Wollongong Local Planning Panel Assessment Report – Electronic Meeting

WLPP No.	Addendum Report
DA No.	DA-2021/542
Proposal	Residential - minor demolition works and alterations to existing building and use of building as a multi dwelling development - three (3) dwellings
Property	195 Lawrence Hargrave Drive, THIRROUL NSW 2515
Applicant	JIH Building Design Pty Ltd
Responsible Team	Development Assessment & Certification – City Wide Planning Team (RT)

ADDENDUM REPORT

DRAWING: NE & SW Elevations

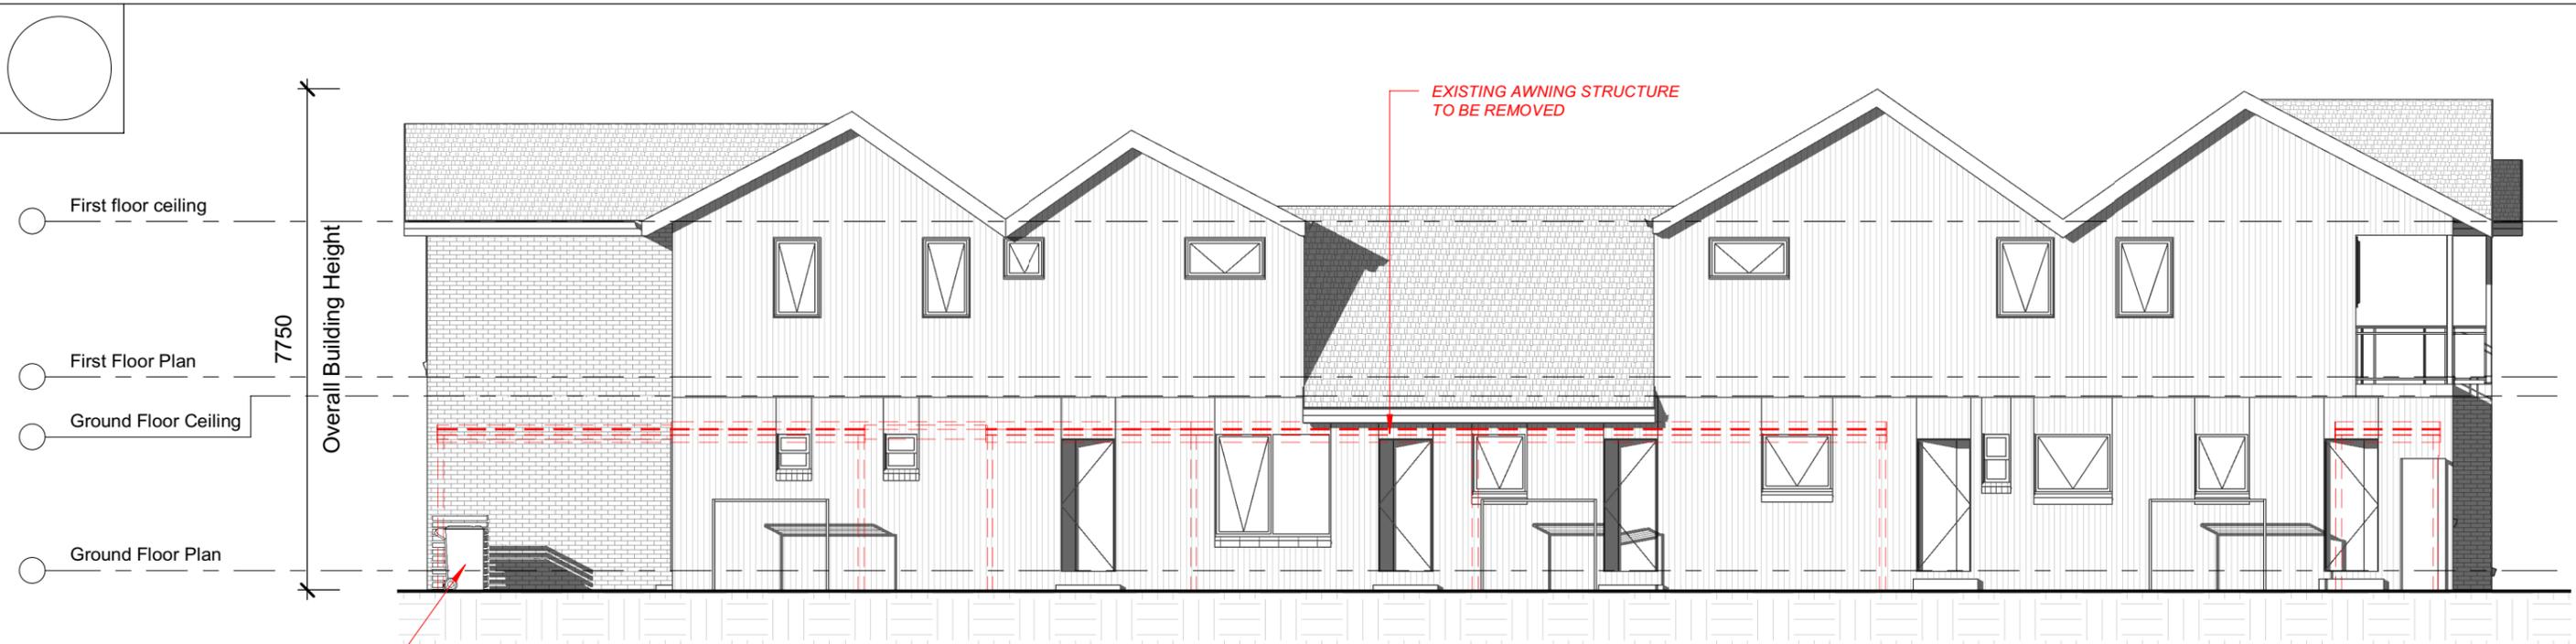
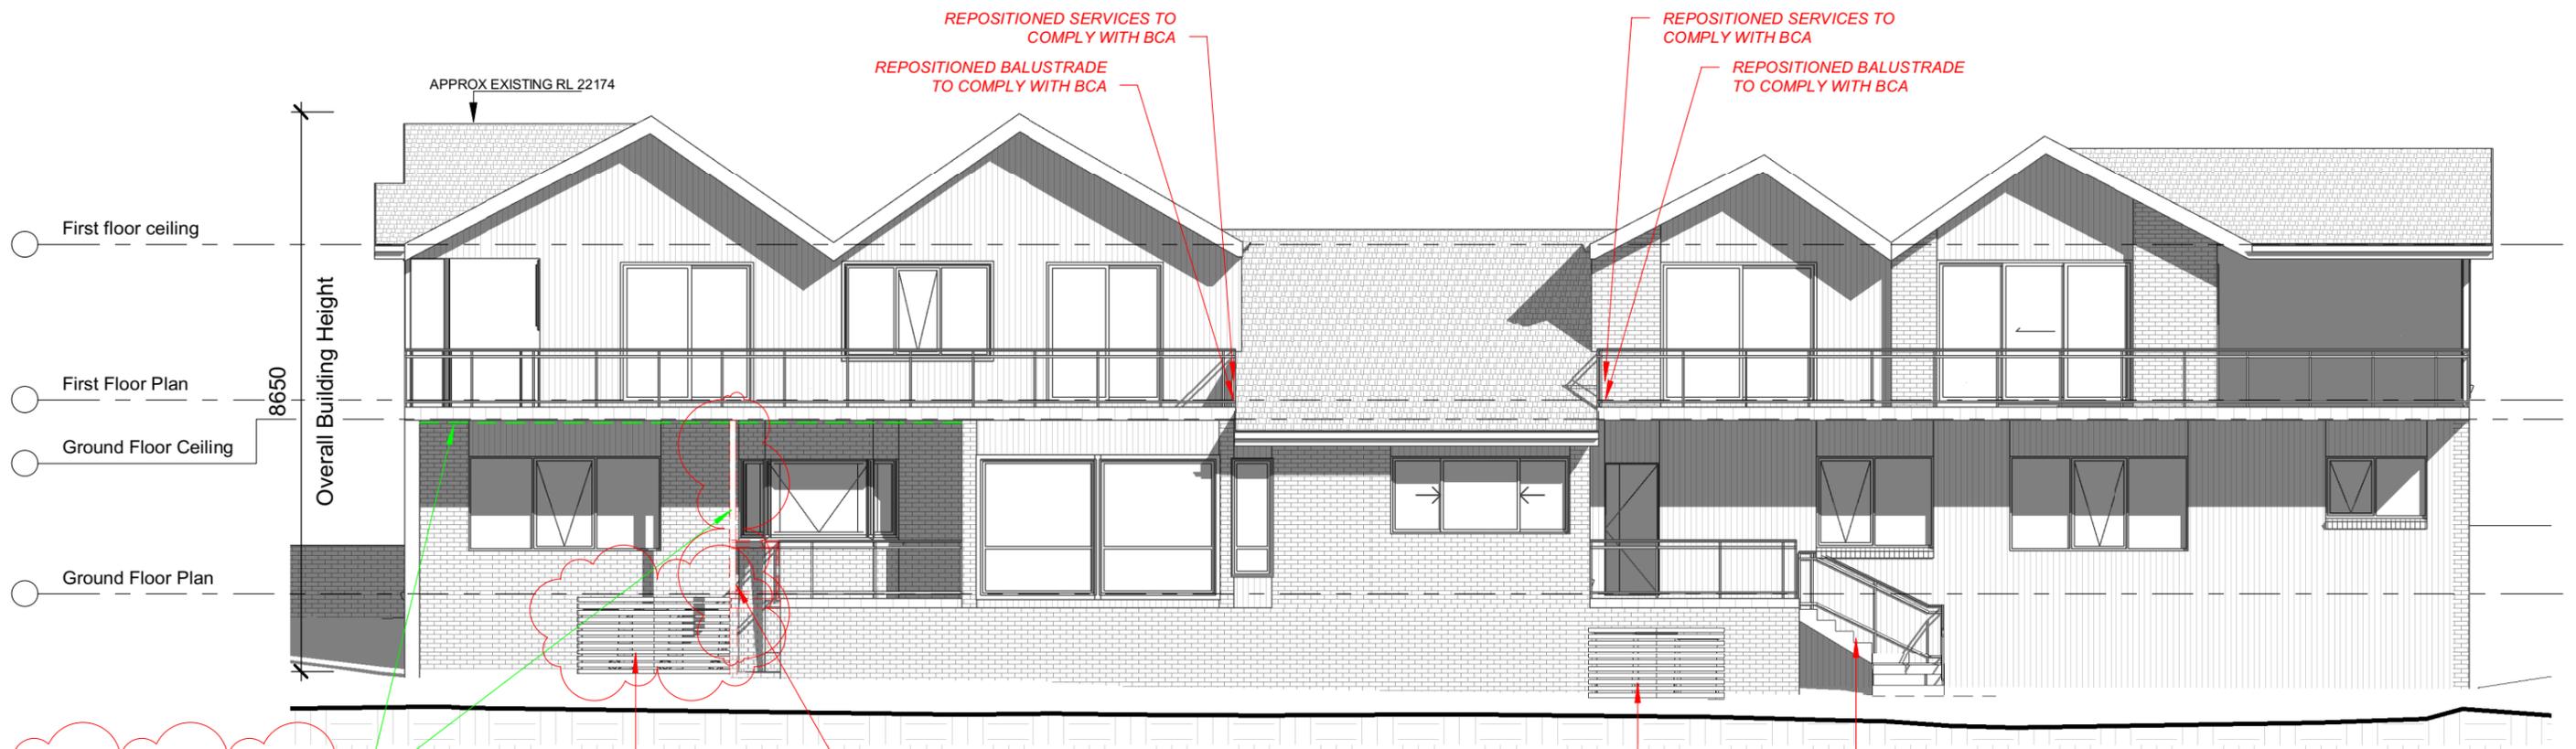
- d. Coloured in blue, the elements of the building which have been constructed without consent.
 - e. The garbage storage to unit 1 to be relocated to the Jones Lane frontage and enclosed.

The garbage storage for Unit 1 has been relocated to the Jones Lane frontage of Unit 1. The Site Plan, Ground Floor Plan and South west Elevation have been amended as at Attachment 2 to reflect the requested change.

LANDSCAPE PLANTING SCHEDULE

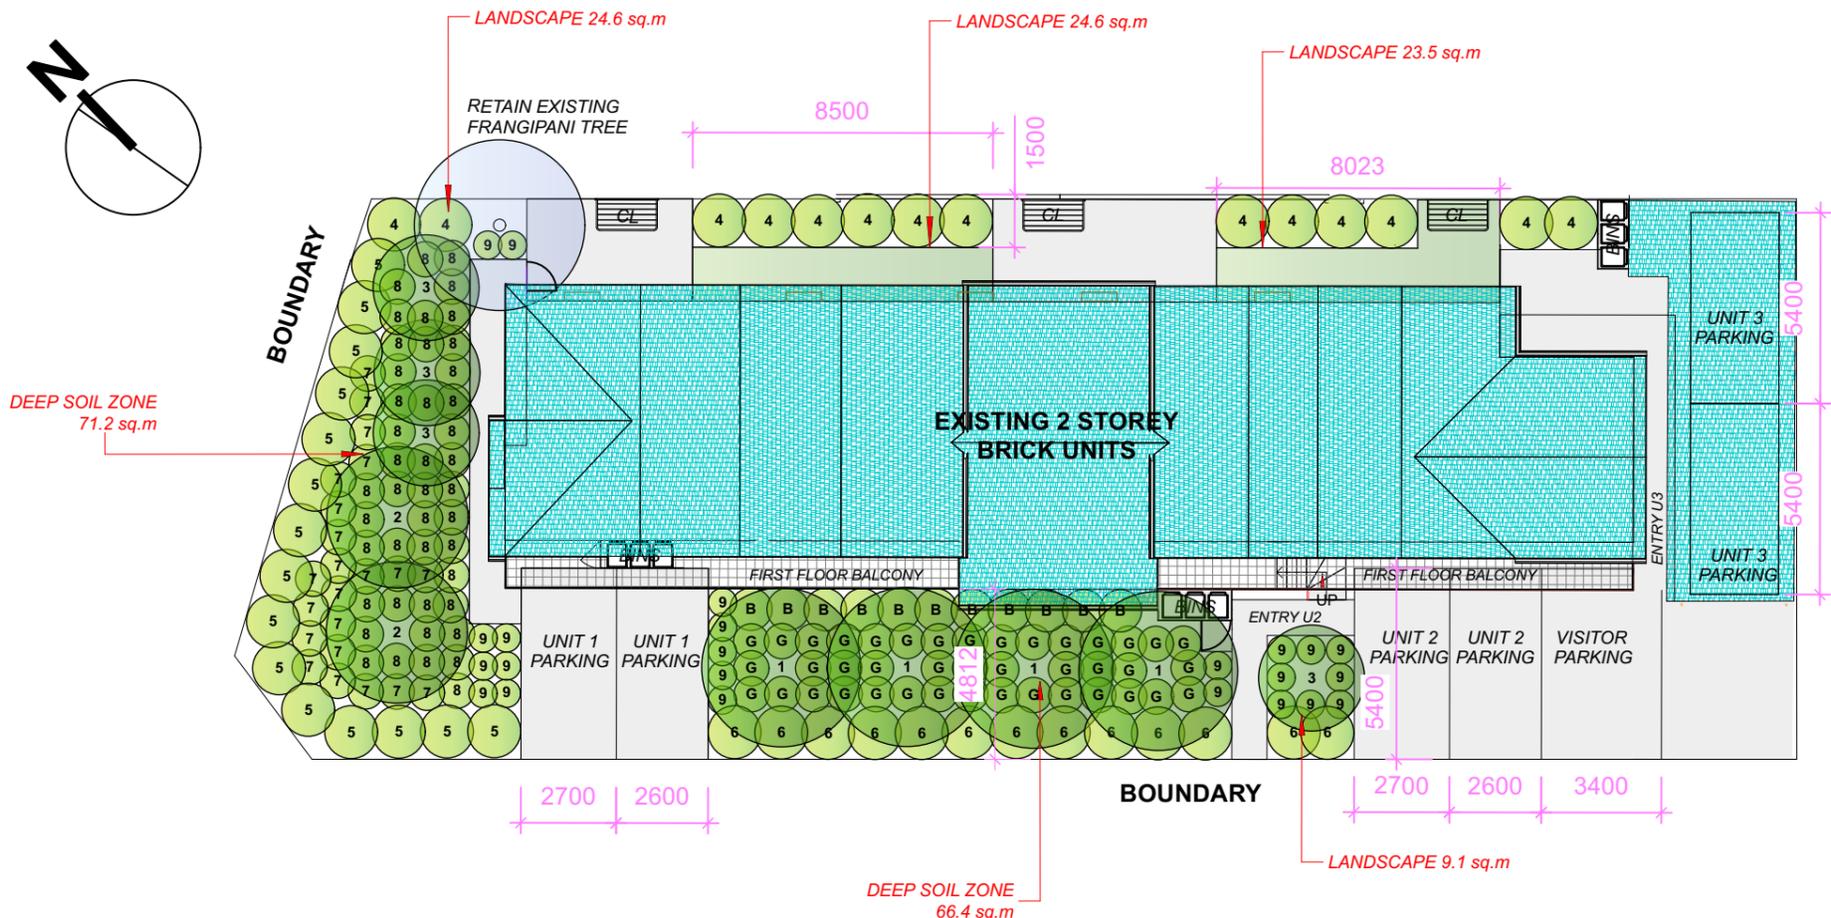
- “1. The plans lacked clarity, accuracy and consistency and the Panel requires the following to be documented on all the plans:
 - a. The frangipani tree to be retained.

- b. The proposed new path and breach in the wall on the Lawrence Hargrave Drive frontage to be deleted from the landscape plan.
 - c. The steps from all units to the rear courtyards.

An amended Site Plan and Landscape Plan has been submitted as at **Attachment 2** detailing the retention of the frangipani tree.

An amended Landscape Plan has been submitted as at **Attachment 2** deleting the proposed new path and breach in the front fence/wall.
